RE: City of Gainesville  
Gainesville Regional Utilities  
J. R. Kelly Generating Station  
Draft Title V Permit No. 0010005-001-AV

J. R. KELLY GENERATING STATION  
COMMENTS ON DRAFT TITLE V PERMIT NO. 001005-001-AV

DOCUMENT II.E.2.  
FACILITY PLOT PLAN

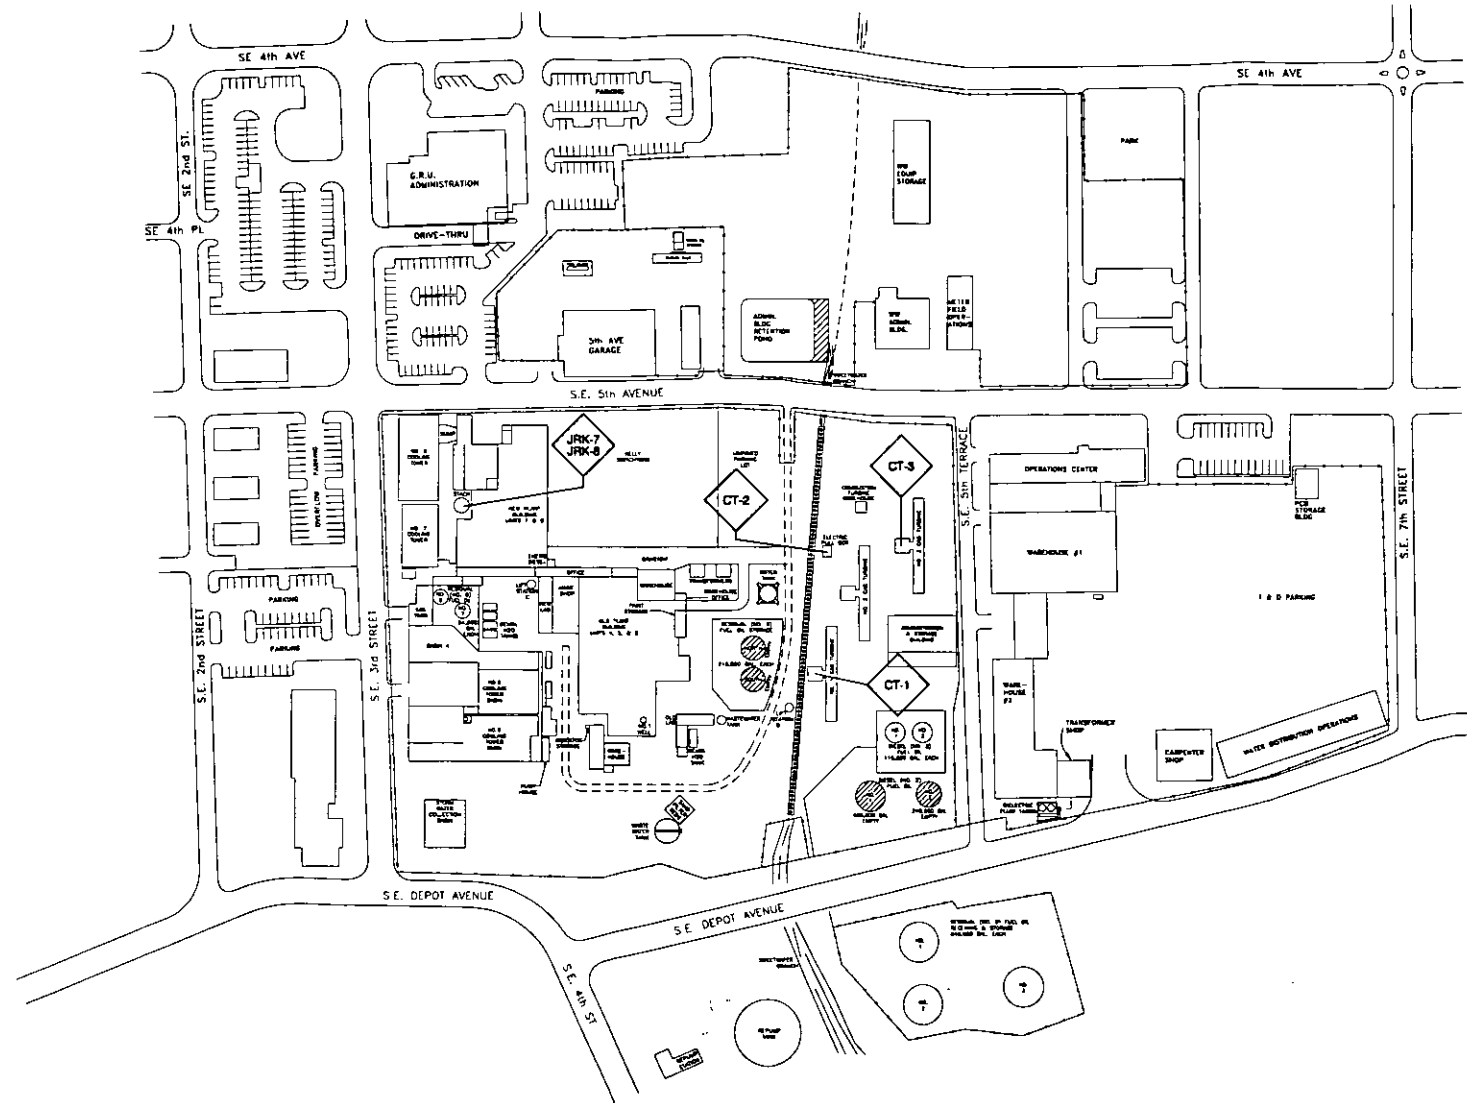
REVISION	DATE
DELETE UNIT 6 STACK	9/15/97
